# dsPIC33EPXXXGP50X, dsPIC33EPXXXMC20X/50X and PIC24EPXXXGP/MC20X

## dsPIC33EPXXXGP50X, dsPIC33EPXXXMC20X/50X and PIC24EPXXXGP/MC20X Family Silicon Errata and Data Sheet Clarification

The dsPIC33EPXXXGP50X, dsPIC33EPXXXMC20X/50X and PIC24EPXXXGP/MC20X family devices that you have received conform functionally to the current Device Data Sheet (DS70000657H), except for the anomalies described in this document.

36-Pin UQFN<sup>(1,2,3)</sup>

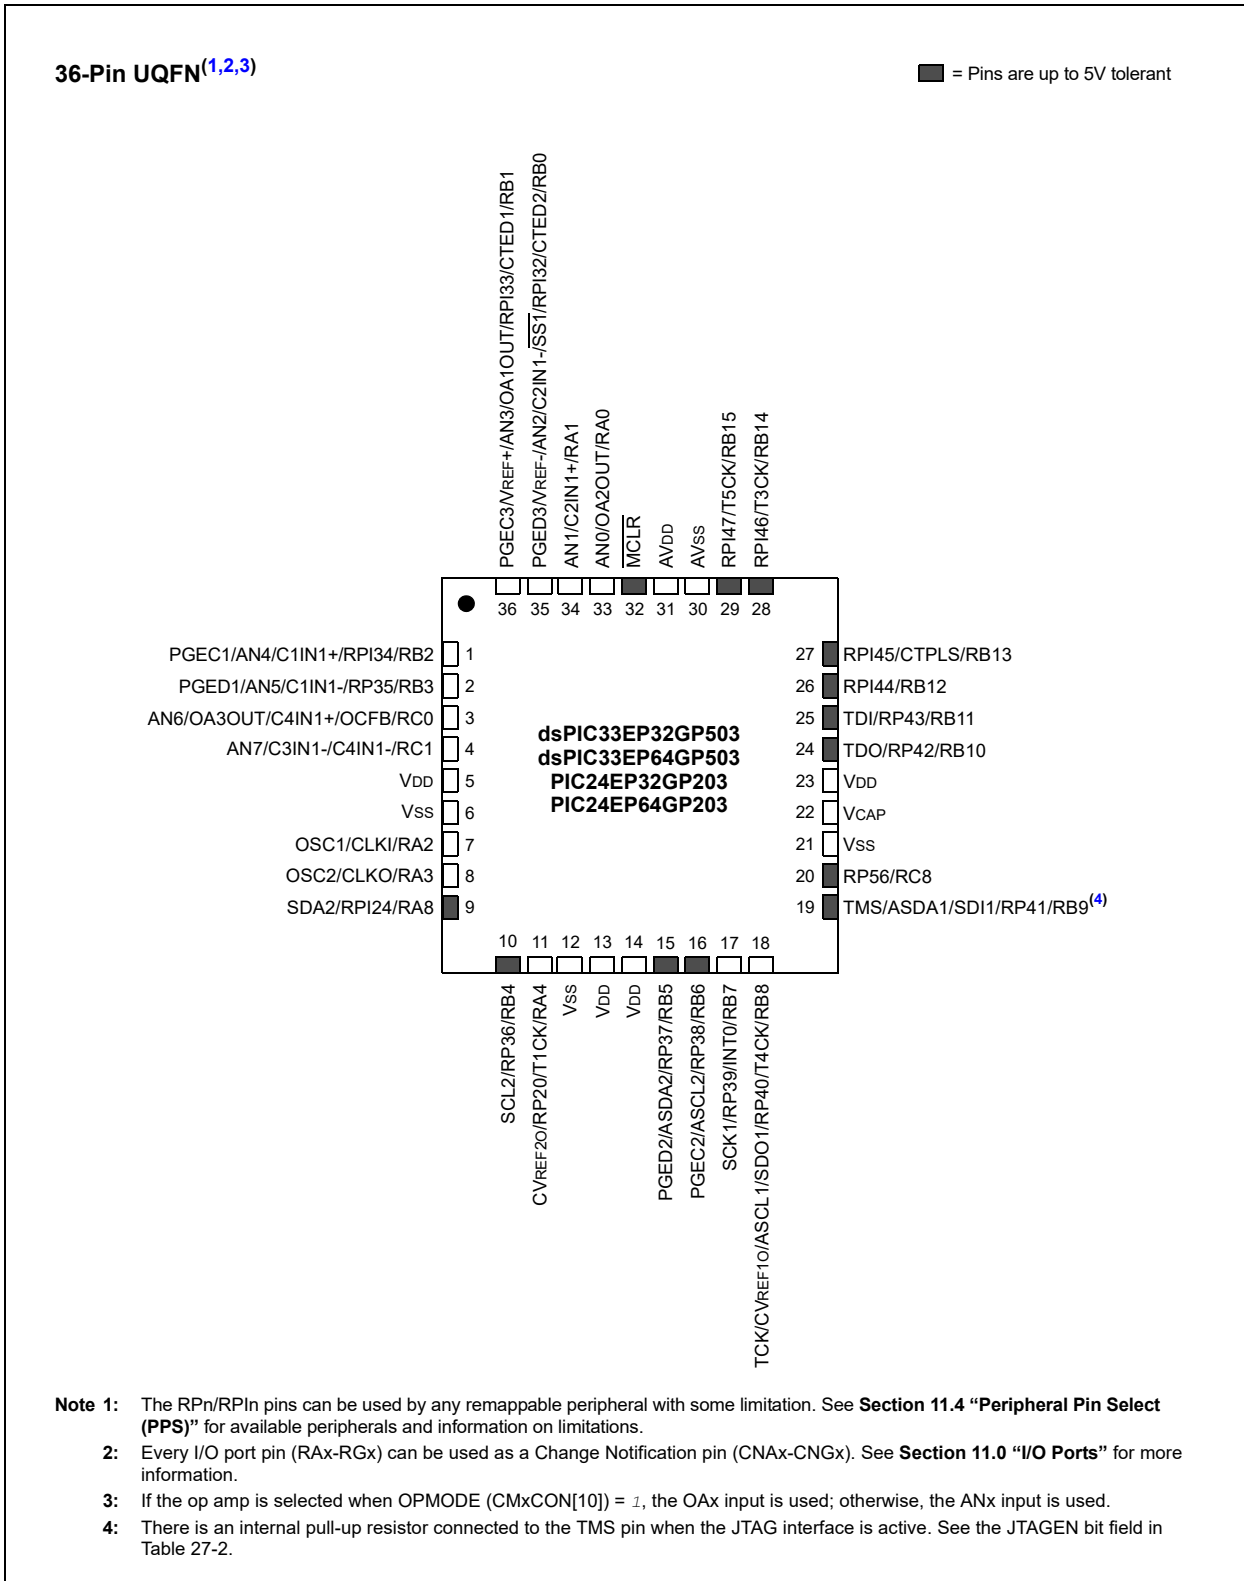
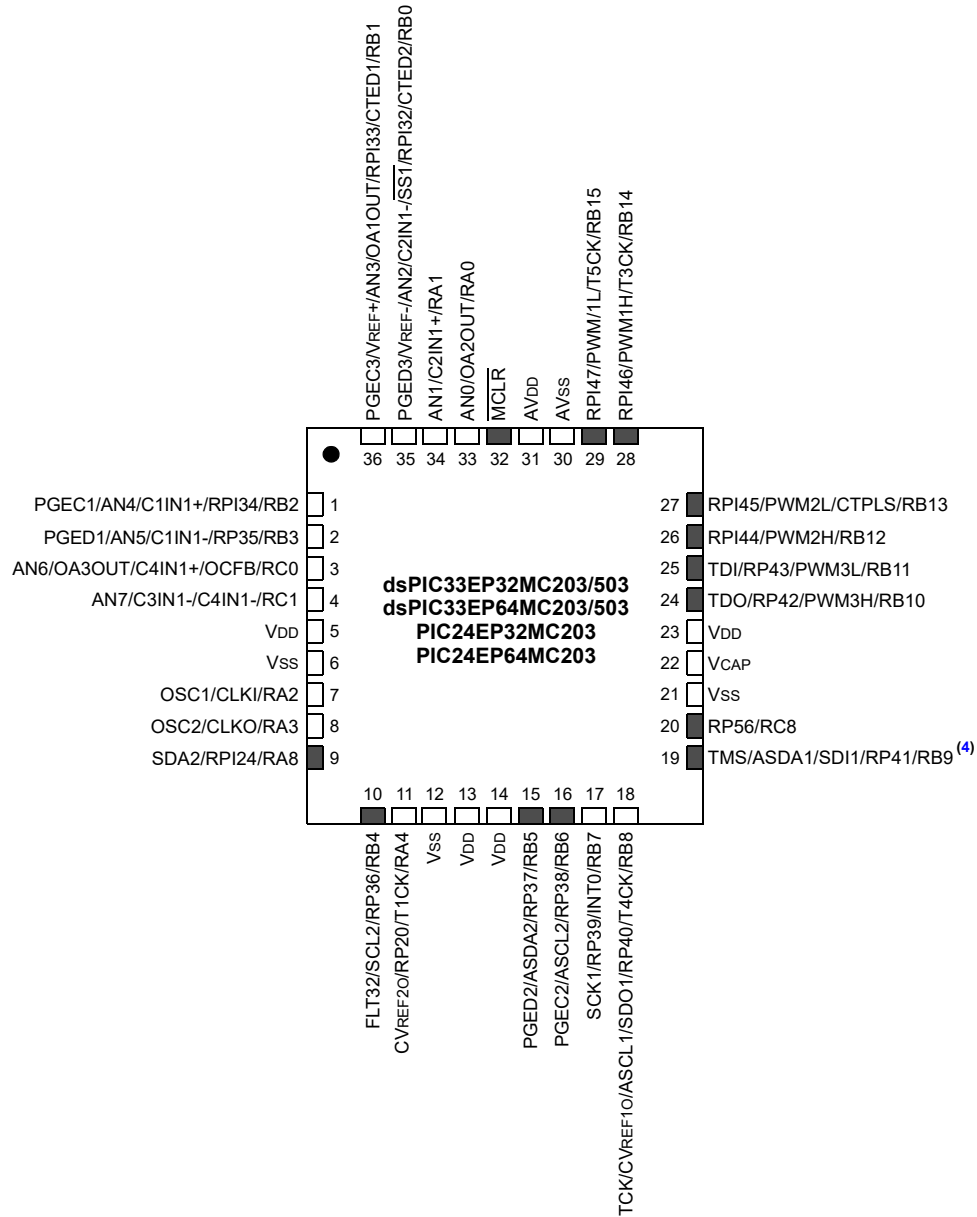
The following two 36-pin UQFN diagrams are added to the “Pin Diagrams” section of the data sheet.

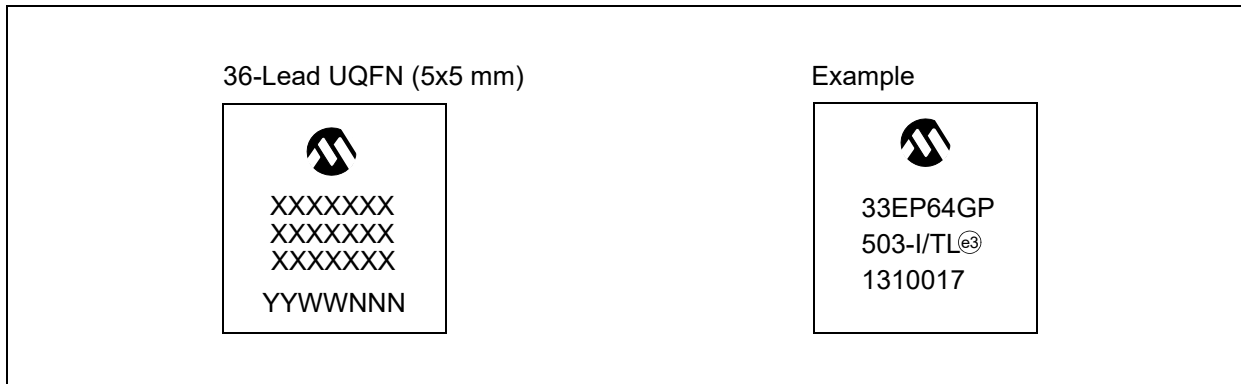
The following drawing of the 36-pin UQFN package marking is added to **Section 33.1** “**Package Marking Information**”.

36-Lead Ultra Thin Plastic Quad Flat, No Lead Package (M5) - 5x5 mm Body [UQFN] With Corner Anchors

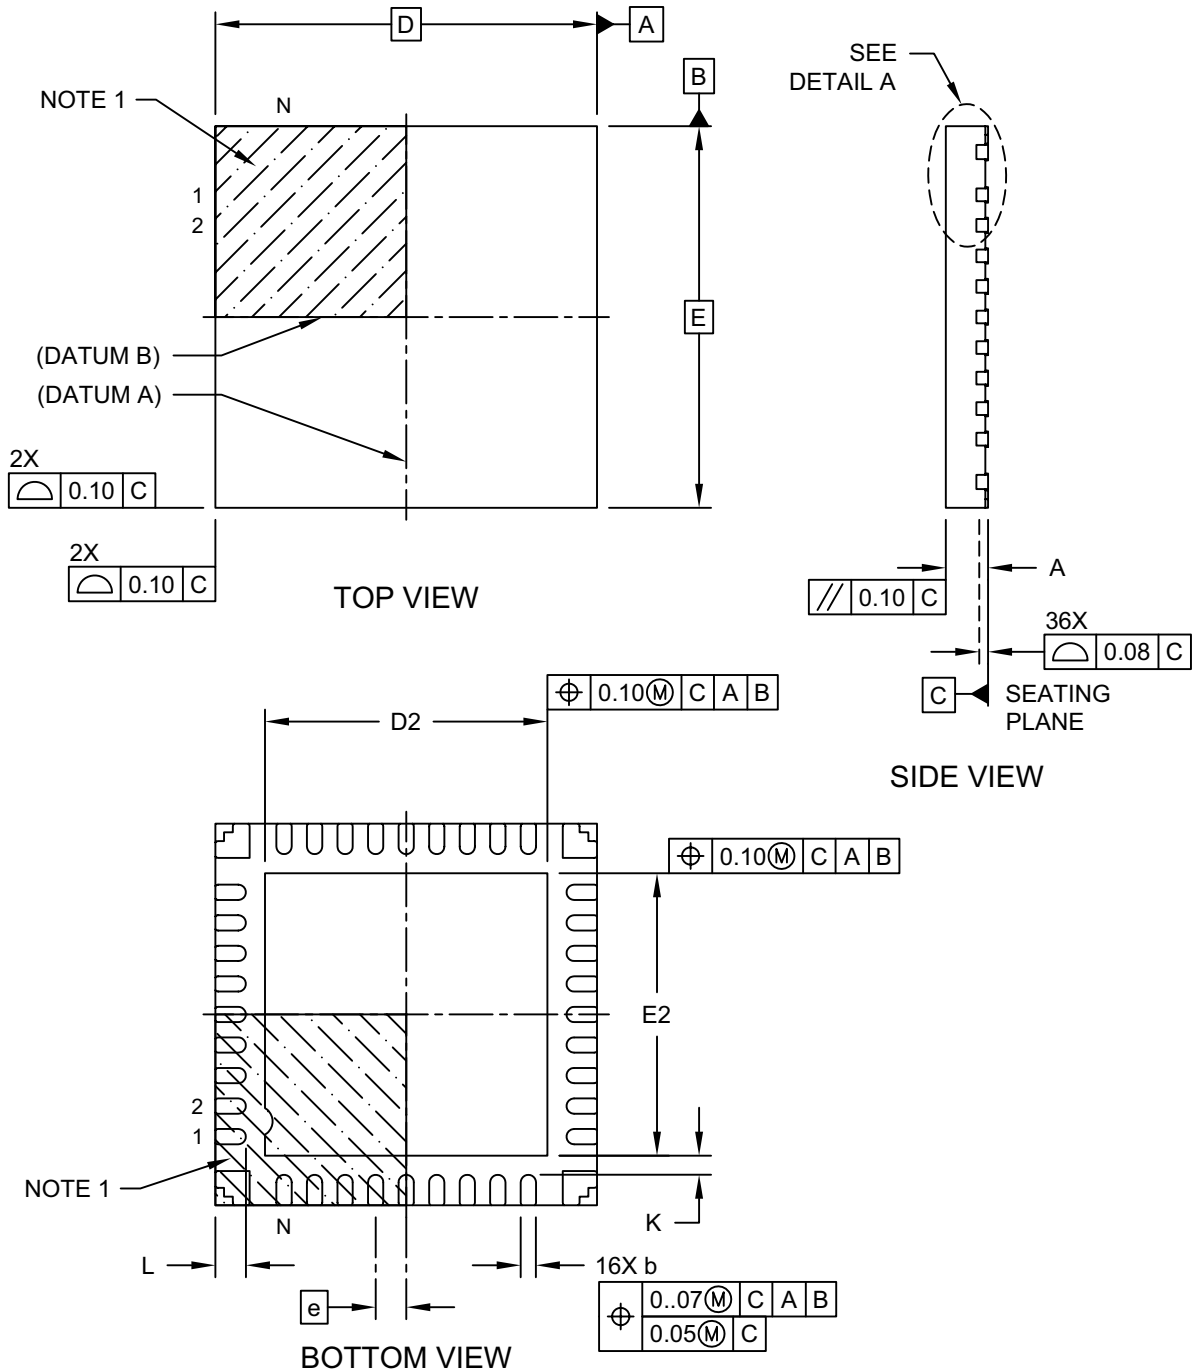
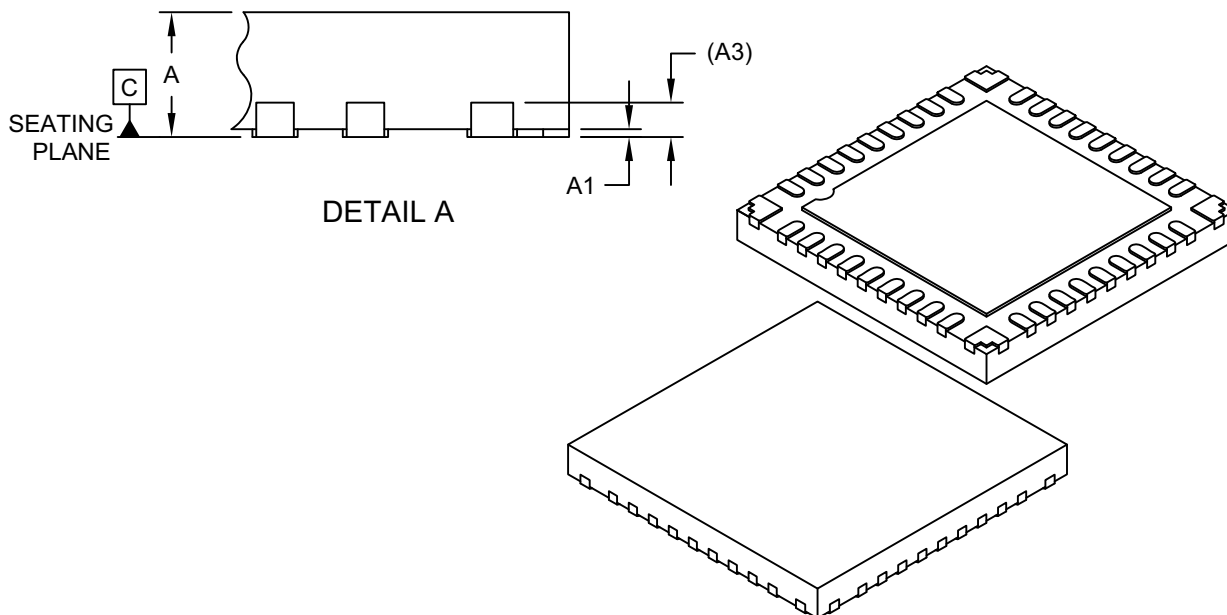
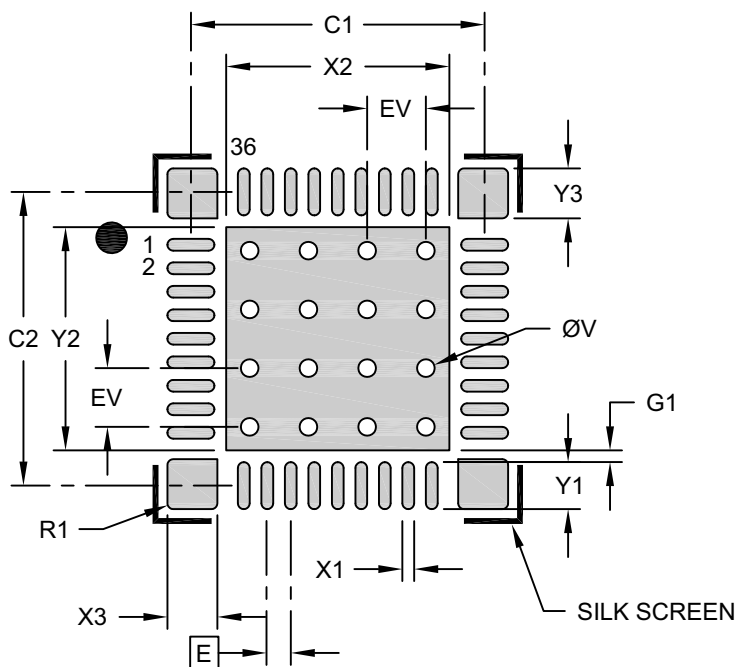
The following three new drawings of the 36-pin UQFN package are added to Section 33-2 "Package Details".
